CN20006: RTG4 Family Important Changes

May 6, 2020

This document describes the following three changes to the RTG4 product family.

Figure 1 • RTG4 Programming Options GUI

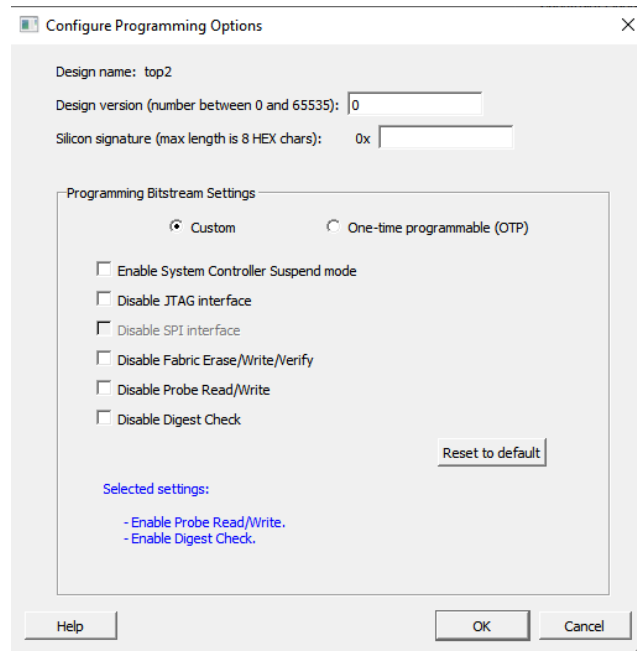
In Libero SoC v12.0 to v12.3, using the configuration tool to “Configure I/O States During JTAG Programming” can cause a loss of user programming settings selected via “Configure Programming Options”, “Configure Action/Procedure” for the “Run Programming Action” step, and “Generate Bitstream” options.

When operating an RTG4 device, if System Controller Suspend mode is selected, this issue could permanently prevent the device from exiting System Controller Suspend mode, and permanently lose the capability of reprogramming the device. We recommend upgrading to Libero SoC v12.4.

- For RTG4, this issue only occurs if running “Configure I/O States During JTAG Programming” in Graphical User Interface (GUI) mode.
- There is no issue if the “Configure I/O States During JTAG Programming” GUI is not used, no issues in Tcl scripted mode.

Do not program any further RTG4 devices with programming files (Libero SoC v12.0 to v12.3) using I/O states during programming GUI combined with the programming options listed above. Upgrade to Libero SoC v12.4, observe that all "Generate" and "Export" programming steps in the design flow will be invalidated, then re-run I/O States GUI and re-configure Programming/Bitstream options prior to Generating and Exporting new bitstreams.
